**Re: [EXT]**

I have been going through the PDFs, and have a few questions.

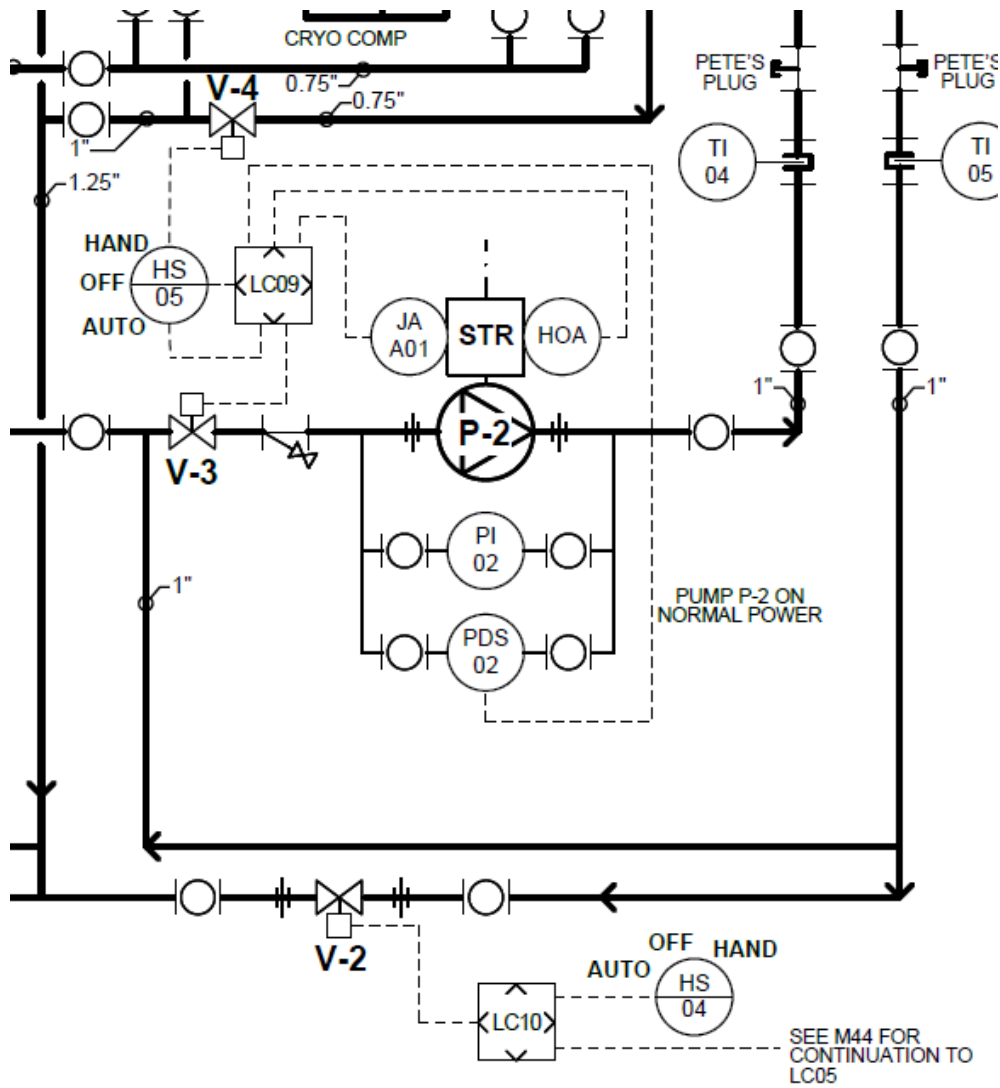
is V-A1 referring to V-1?

Should HS-05 and HS-04 be switched in location on the P&ID Page?

Should this be TS-01?

Yes, V-A1 should read V-1.

In the section currently reading as "Manual selector switch HS04...", replace HS04 with HS05 and HS05 with HS04.

In the section currently reading as "Manual selector switch HS05...", relace HS04 with HS04.

Regarding the TS01 and TS02 setpoints - I have to rewrite these sections. I think I will also simplify the number of logic controllers. Back in earlier versions, we had redundant control valves for V-1 and V-2 (hence the V-1A and V-1B, etc.) that required additional logic and dedicated binary acting isolation valves at each modulating control valve. Requirements got simpler, budgets got tighter, and an overall control philosophy of subcooling then reheating to a tight tolerance was adopted which allowed for less expensive chilled water control valves. The control valves are actually pretty reliable, and I was probably overreacting in the early days of design providing too much redundancy. At some point, more parts and control begin to create

### Outer Enclosure Temperature Control – cont.

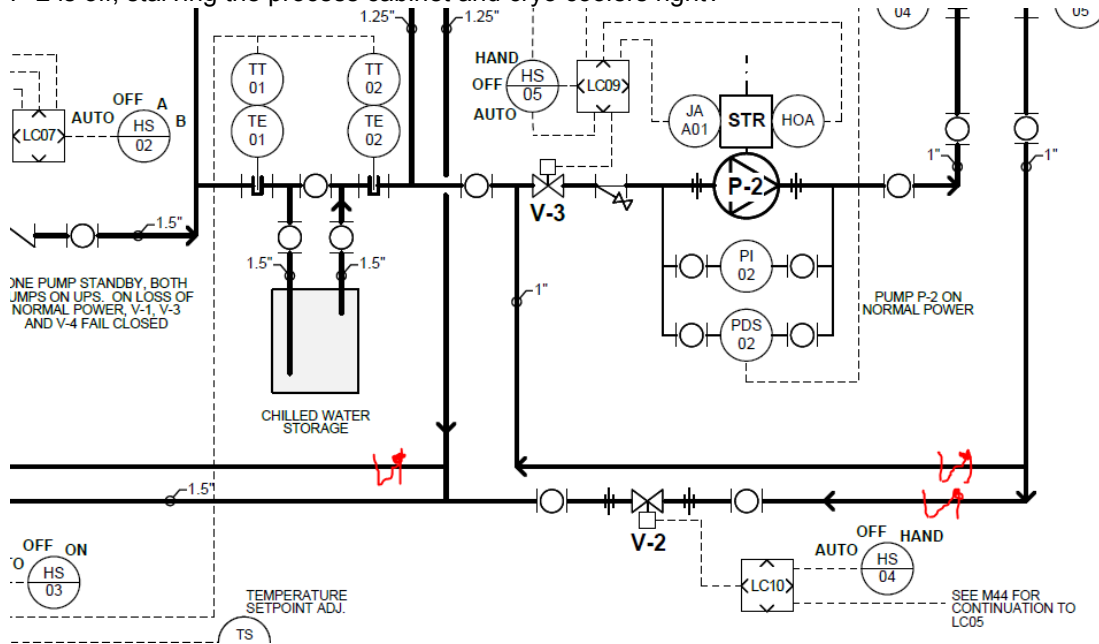
Can you make the following paragraph a little more clear? and instead of using the LCXX notation use the actual sensor or element labels such as TE-11.

DO we want to have check valves in these locations? water will be shunted back to the return of the secondary loop if

P-2 is off, starving the process cabinet and cryo coolers right?

All that said, I need to spend some quite time with the SOOs and wring out some of the legacy design and make sure the control loops are clean, not interacting with each other, etc. The TS01 and TS02 are examples of poor coordination on my part. Each has a very specific purpose (one loop to manage the leaving temperature of the cooling coil and the second fast loop to do the final reheat to meet the outer enclosure temperature set point). But they are spread across two sheets (4-1B and 4-2) so I need to get them coordinated properly. I've moved point numbers around so many times that it is generating confusion for those who are actually looking this material over with a critical eye. I don't want to waste your time so instead of fixing this on the fly, I really want to spend a couple of hours doing the cleanup. And I want to do that AFTER we've had some time to agree on how many logic controllers are really needed, etc. I think we can do this pretty quickly just by considering the various loop that are needed.

ps. I don't think your proposed check valves are needed; they don't hurt except a small pressure drop but I'll be happy to trace the flows with you to make sure some odd set of circumstances doesn't produce the conditions you are worried about.
